### ARCHITECT'S SUPPLEMENTAL INSTRUCTION NO. 6

DATE: March 13, 2024 PROJECT NO: 230117

RE: Streets of West Pryor - Lot 5 Core & Shell

G-001

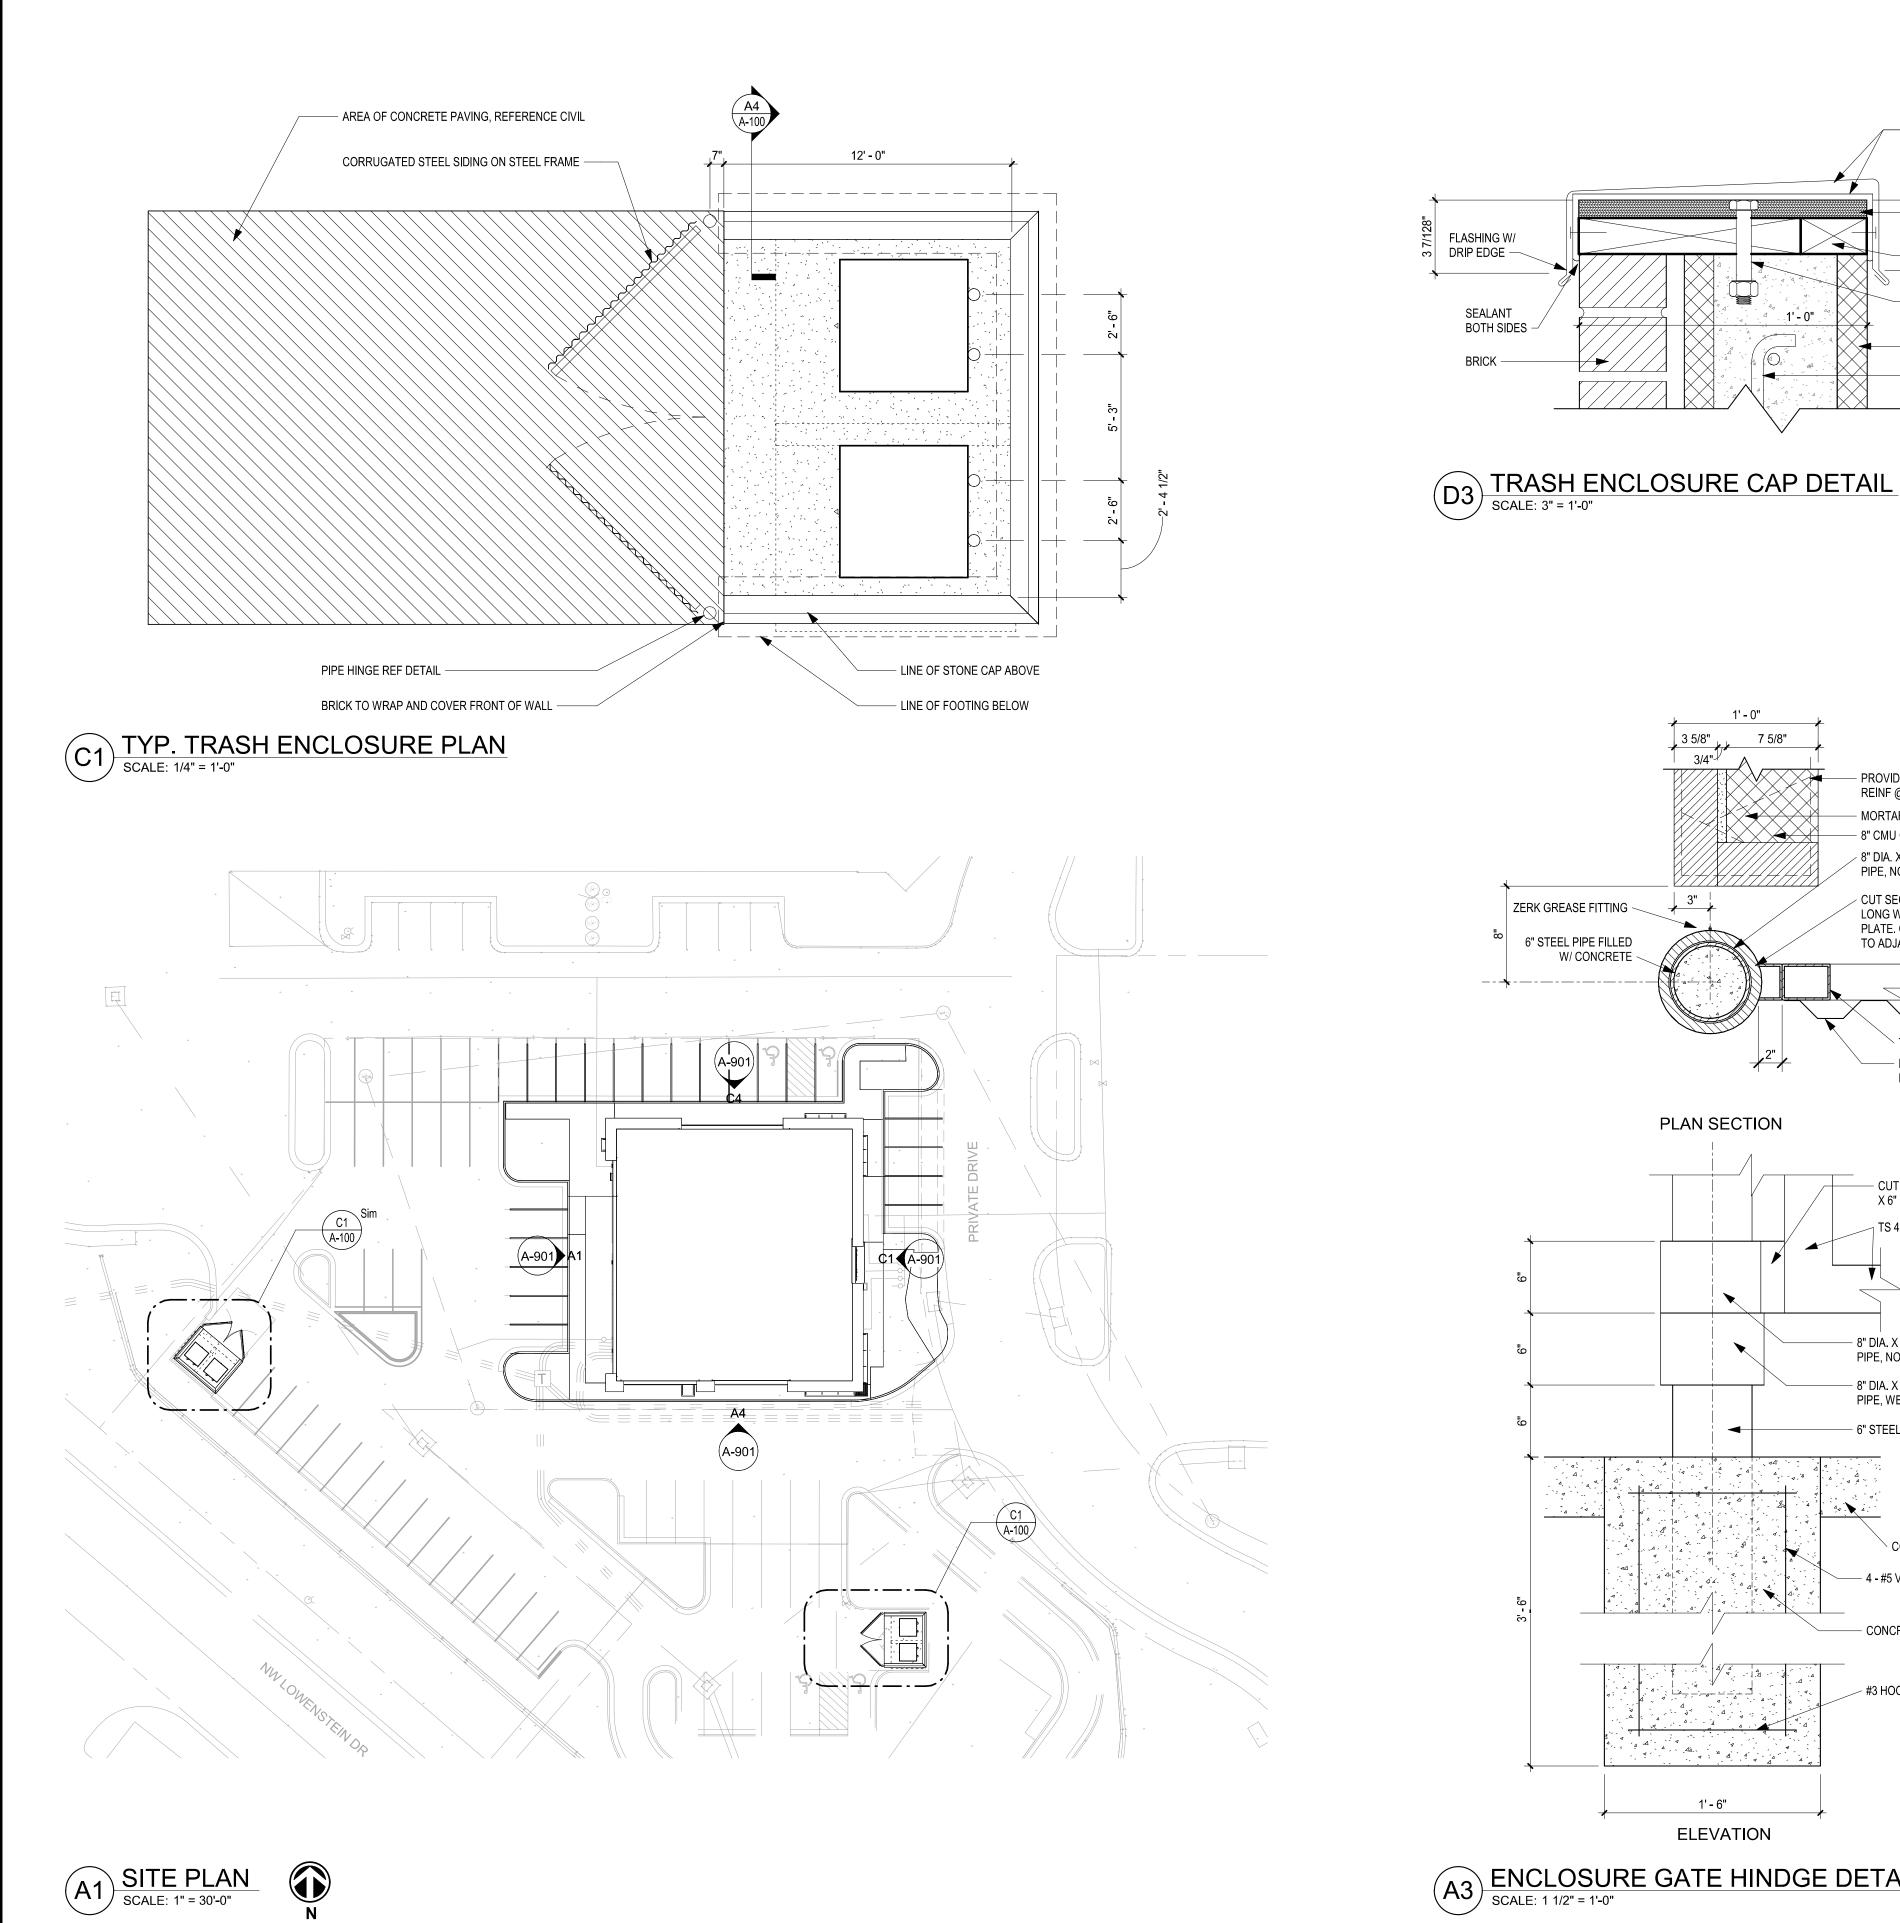
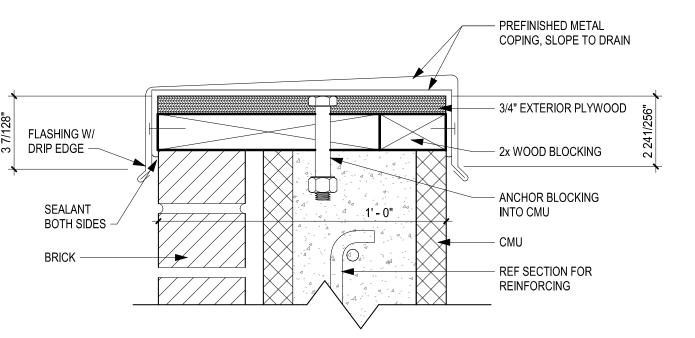
- A-1 Sheet G-001 Code summary updated with usable square foot occupant load calculations and exit requirements for tenant suites A, B & C.
  - A-1.1 Sheet G-001 Code plan updated with occupant load calculations and egress width for tenant suites A, B & C.
- A-2 Sheet A-101 Two hour rated demising wall added to full East to West length of the building spaced 21 feet from face of gypsum board to the other second two hour rated demising wall. Creating and dividing the Core & Shell building into now three separate tenant suites.
  - A-1.A Updating tenant suite designations as Suite A, B & C respectively.
  - A-1.B Updating tenant suite square footage.
- A-3 Sheet A-102 Roof Top Unit added to service enlarged Tenant Suite B space.

FIRST FLOOR PLAN

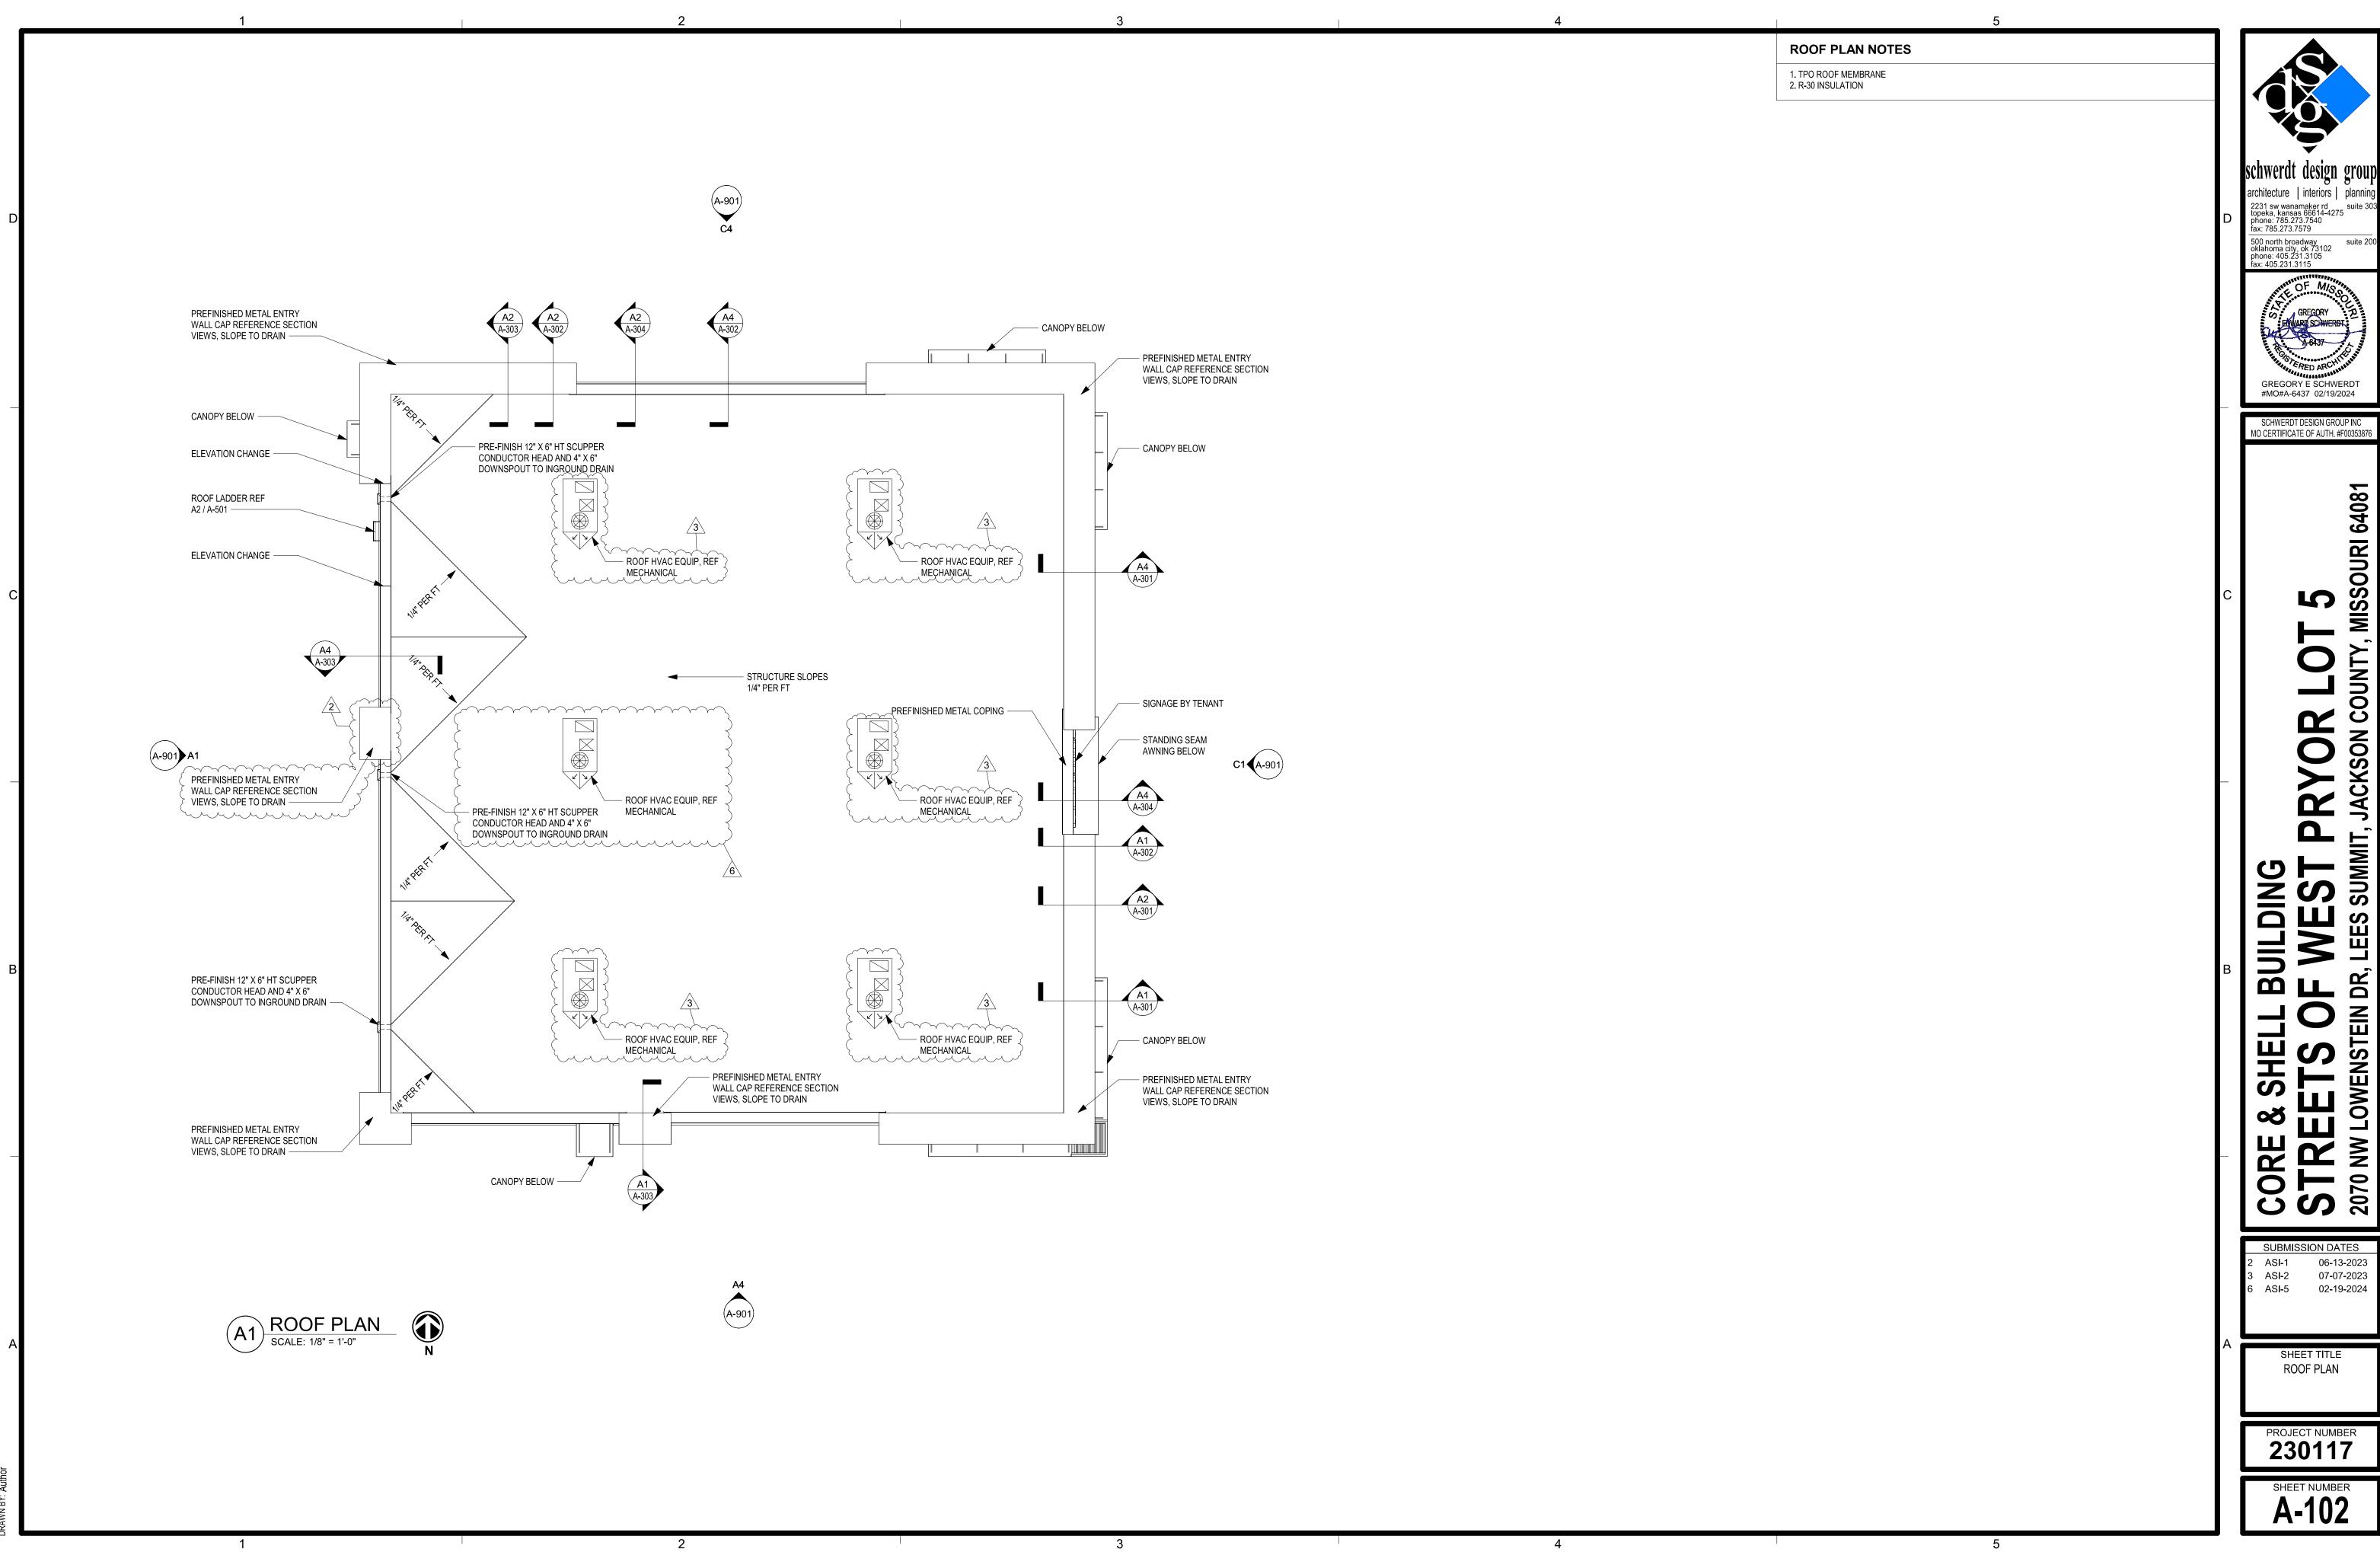
- A-1 Sheet G-001 Drawing A3-Code Plan changed from 3 tenant building to 2 tenant building.
  - A-1.A Drawing A3-Code Plan updated egress load tags.
- A-2 Sheet A-101 Floor changed from 3 tenant building to 2 tenant building. Including removal of fire demising wall, restroom and mechanical room.
  - A-2.A Room tags updated to illustrate proper Suite nomenclature and square footage.
- A-3 Sheet A-201 Drawing C1-East Elevation update illustrating change to Stone wainscot and EIFS 1 at previous brake metal pilaster.
  - A-3.A Drawing C1-East Elevation changed from 3 tenant building to 2 tenant building and tenant signage updated on elevation.
- A-4 Sheet A-401 Removed from scope.

A-1 Sheet A-101 – Updated location of future pass-through openings on Suite C's South demising wall.

- A-1 Sheet A-101 Future pass-through openings added on East and West ends of Suite C's South Demising wall.
  - A-1.A Key plan note #2 for Future pass-through added to Keyed Plan Notes legend.
- A-2 Sheet A-102 RTUs rotated 90 degrees for structural support purposes.
- A-3 Sheet A-201 Door C101 update to be 7' and Tempered Glass.
  - A-3.A Reference to MEP exterior utilities indicated on West Elevation Drawing A1.
- A-4 Sheet A-601 Door schedule updated to represent C101 door as 7' and Tempered Glass.

- A-1 Sheet A-101 UL Fire rated wall assembly information has been added to partition type P1.
  - A-1.A Partition types P2 & P3 have been added to partition type legend.
  - A-1.B Partition types P2 & P3 have been tagged in plan.
- A-2 Sheet A-102 Pilaster added to West wall.
- A-3 Sheet A-301 Wall construction updated to clarify horizontal lap aluminum siding.
